FINAL DECISION DOCUMENT
FOR THE INTERIM RESPONSE ACTION
AT THE
COMPLEX DISPOSAL TRENCHES
ROCKY MOUNTAIN ARSENAL
APRIL 1990
CONTRACT NO. DAAA15-88-D-0022/0002
VERSION 4.0

Re: Rocky Mountain Arsenal (RMA)
Proposed Decision Document for
the Interim Response Action
for the Complex Disposal
Trenches, January 1990.

RESPONSE TO COMMENTS FROM THE EPA
ON THE PROPOSED DECISION DOCUMENT FOR THE INTERIM RESPONSE ACTION
FOR THE ARMY COMPLEX DISPOSAL TRENCHES

Figure 2-2

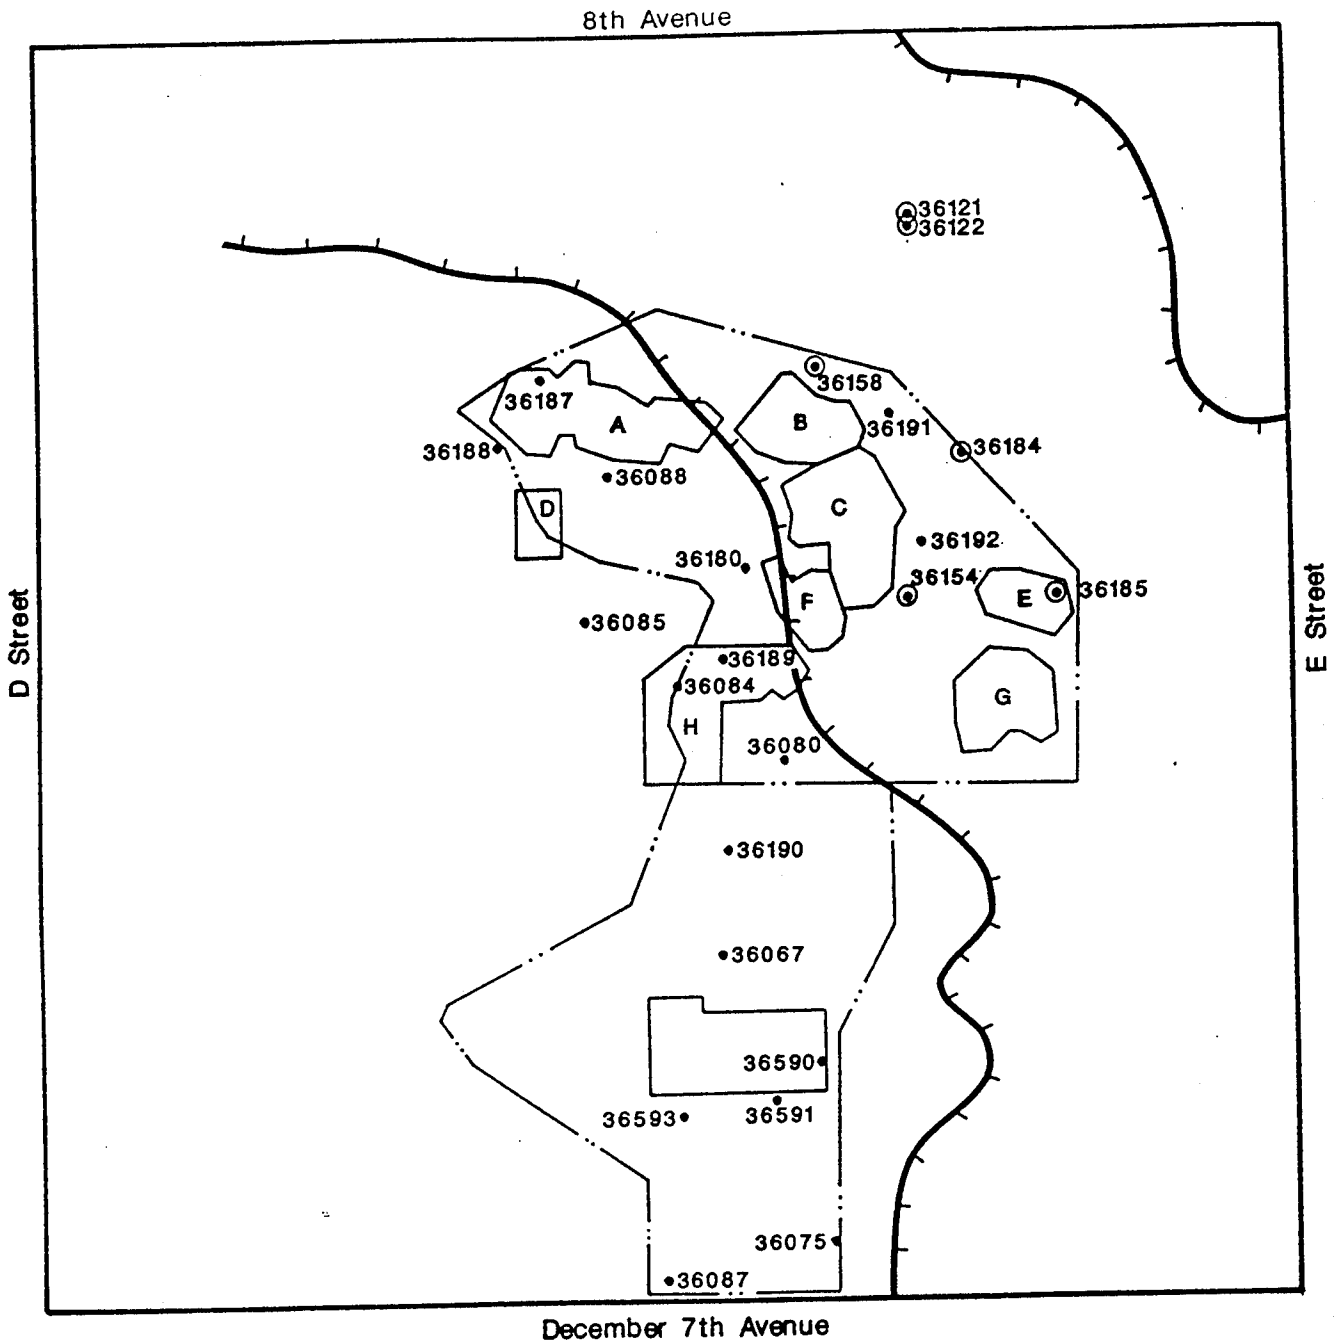
Comment 4: The shaded areas of Figure 2-2 need to be darkened or crosshatched to stand out clearly.

Comment 3: p. 2-4 Figure 2-2 - Location of Trenches in Site 36-17N - This figure appears to be generally lacking in information. Groundwater contamination data for the listed wells are not included, and a number of groundwater monitoring well locations (such as 36090, 36121, 36158, 36184, and 36185) are also omitted. Figure 2-2, or additional figures, should contain such data.

Response: The figure has been revised.

Response: Figure 2-3 has been added to show monitoring well locations. Appendix B was added to the Draft Final Decision Document and includes soil and groundwater contamination data.
